Service Bulletin

Bulletin No.: PIT6452C

Subject: Poor Heater Performance On Drivers OR Passengers Side

7020910

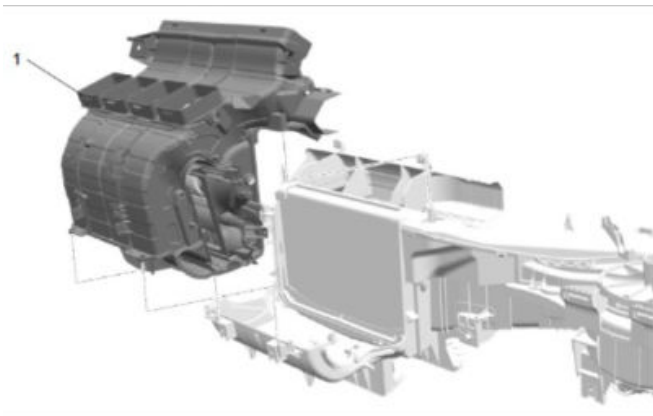
- Access the view through the upper vents or the HVAC evaporator temperature sensor openings.
- Using a borescope, inspect for a disconnected temperature door link. (Note: The mode will have to be set to the vent position, and you will have to enter at the center dash vent for the affected side.)
- Move both the driver's and passenger's temperature doors through their full range of travel while monitoring with the borescope.
- Watch for any binding or resistance that may cause the white temperature door link to separate from the doors or produce a popping noise.

If any door exhibits these symptoms, proceed to Step 2.
